STATE OF CONNECTICUT
CONNECTICUT SITING COUNCIL

DOCKET NO. 436

RESPONSES OF MESSAGE CENTER MANAGEMENT AND NEW CINGULAR WIRELESS
TO CONNECTICUT SITING COUNCIL PRE-HEARING QUESTIONS, SET ONE

Attachment 2

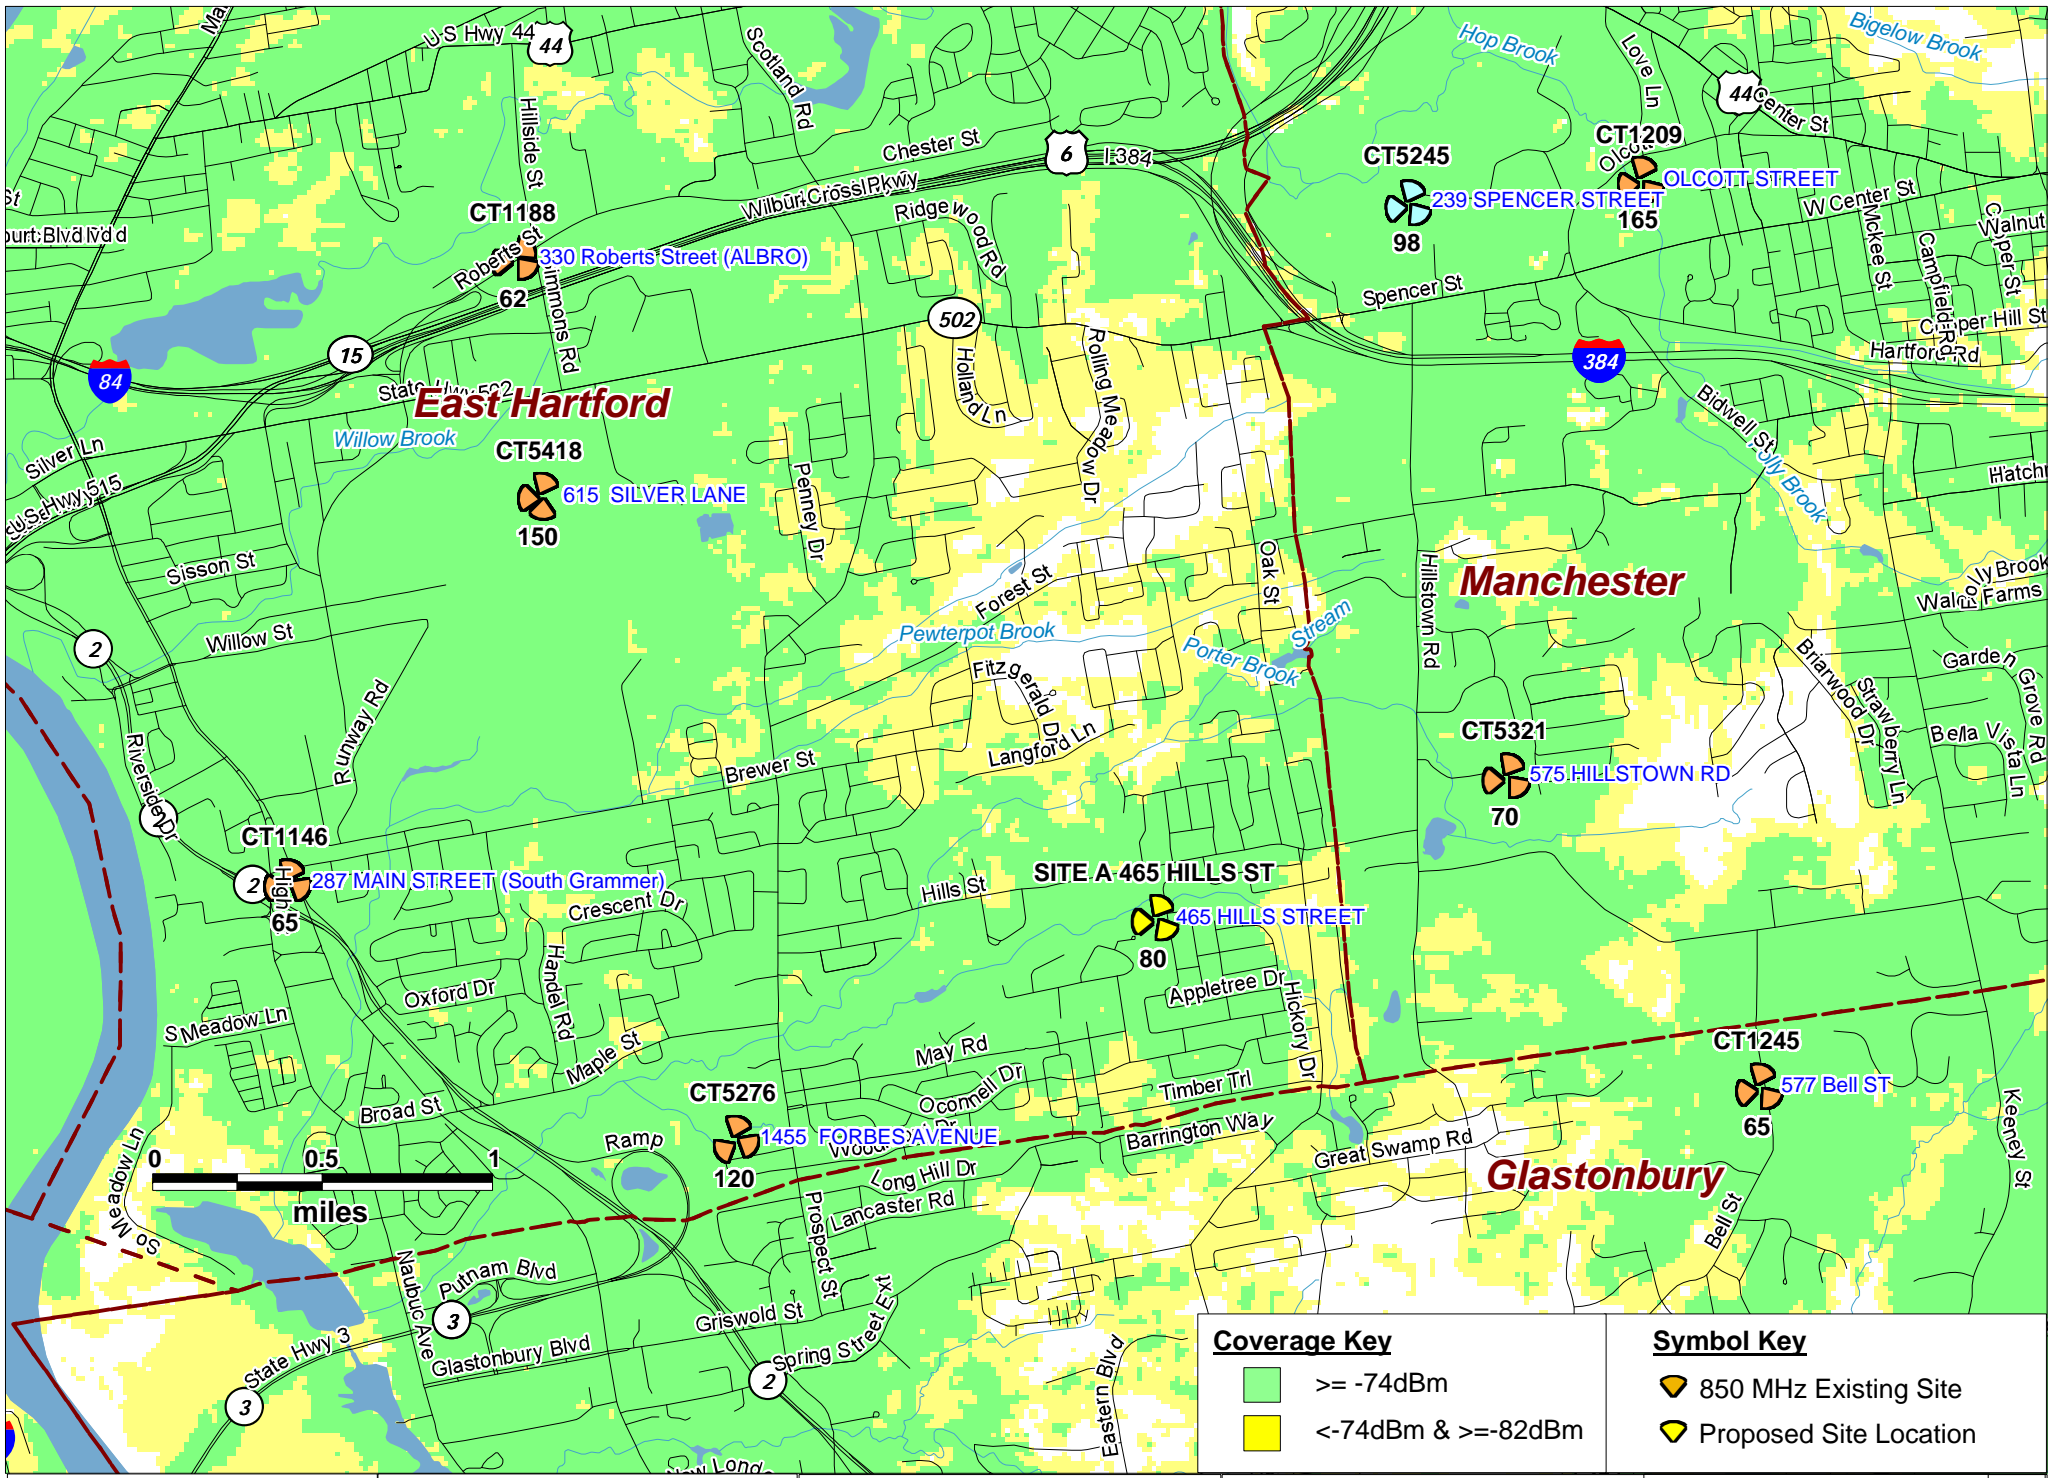
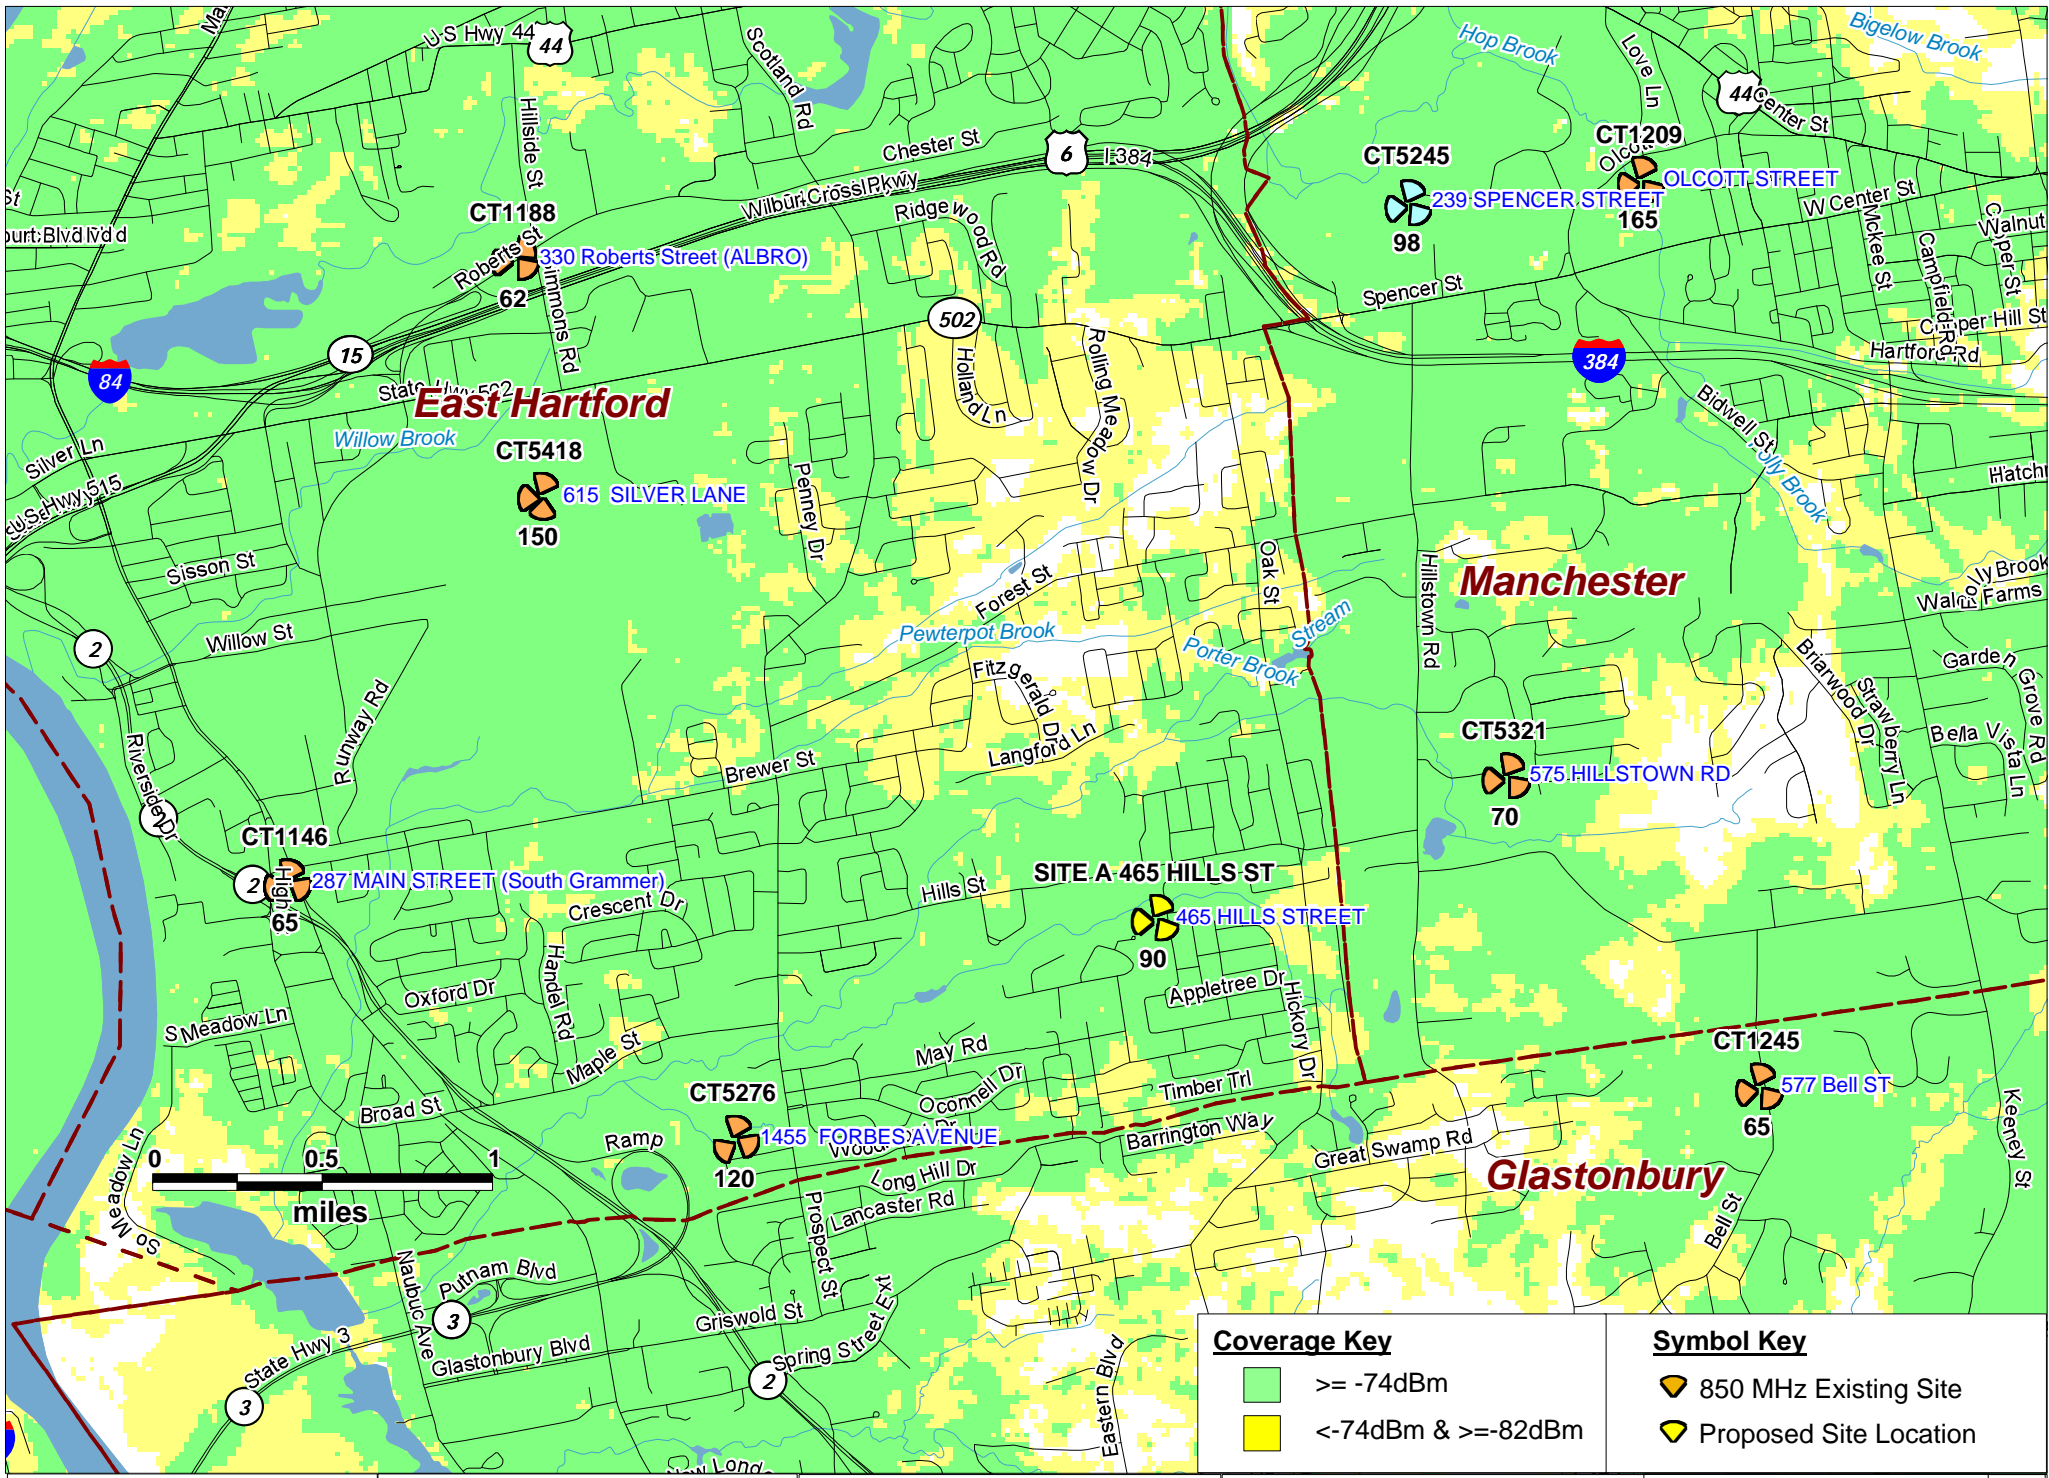
Q23. Using the same scale as the coverage plots in the Radio Frequency Analysis Report, provide separate coverage plots using the same scale provided in the Application assuming the Site A tower is ten and twenty feet shorter.

A23. *Please see requested plots included as Attachment 2.*
